## Development Permit Notice of Decision

**Proposed Development:** **Accessory Building: Semi-Detached Garage w/ Variance (5.49m x 6.10m) (New House Permit No. DB-2025-759)**

**Legal Description:** Plan 252 2038, Block 11, Lot 14  
**Municipal Address:** 5627 Parc Réunis Way, Beaumont, AB  
**Land Use District:** Integrated Neighbourhood  
**Permit Application No:** DB-2025-761  
**Tax Roll:** 011229

**Development Permit Status:** Approved with conditions

Plot Plan  
Your File: ES14-23/24  
DH 10/07/25 PP

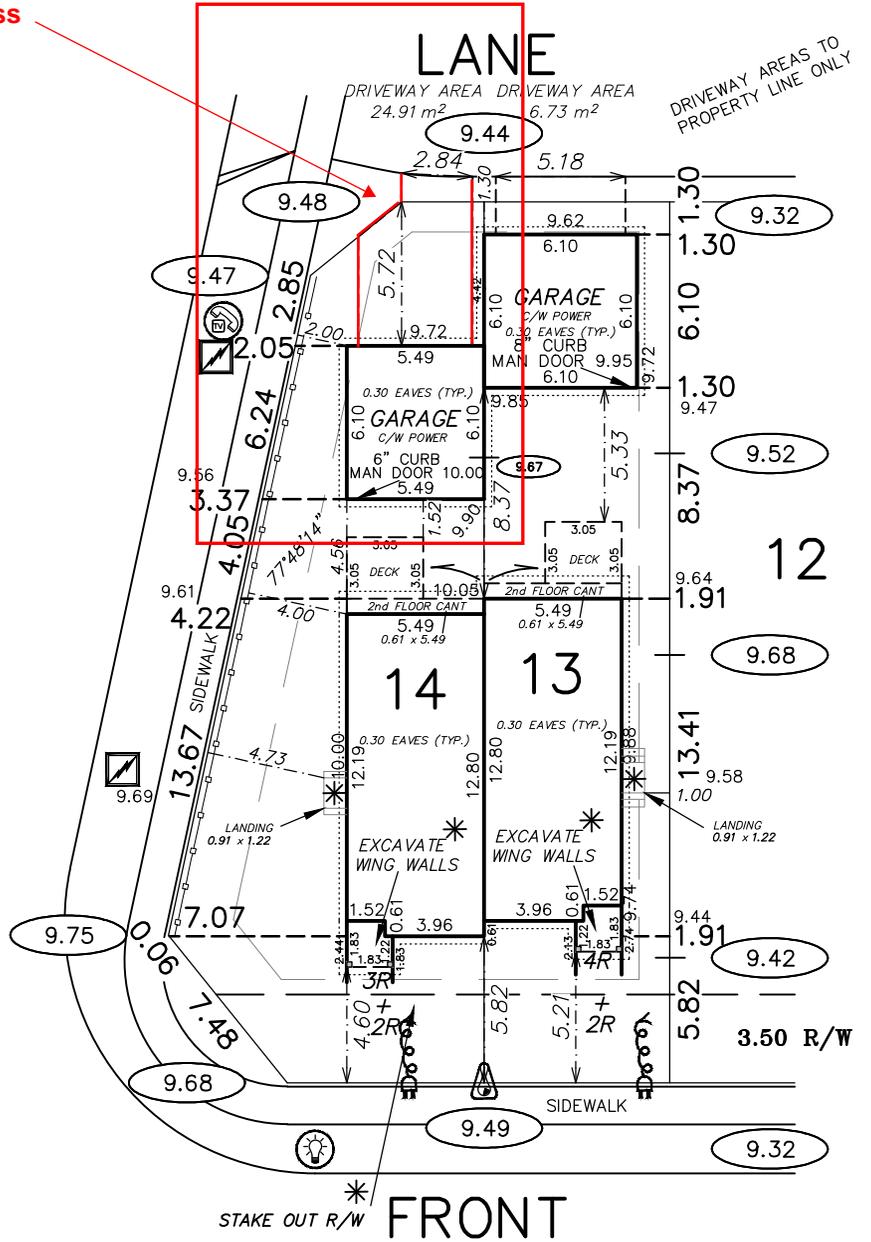
**\*\* Engineered Fill on Lot \*\***

**Encroachment of Driveway/Driveway Apron into the corner cut of lane-way is not permitted; Access approved as indicated**

BASEMENT LOCATION MUST BE EXACT. CONTACT STANTEC GEOMATICS TO PINPOINT WALL LOCATION ON FOOTINGS SURVEY. EDMONTON@STANTEC.COM

GEOTECHNICAL EVALUATION IS REQUIRED PRIOR TO FOUNDATION CONSTRUCTION

**A Variance has been granted to allow the Detached Garage to encroach 0.40m into the side yard setback (see permit conditions)**
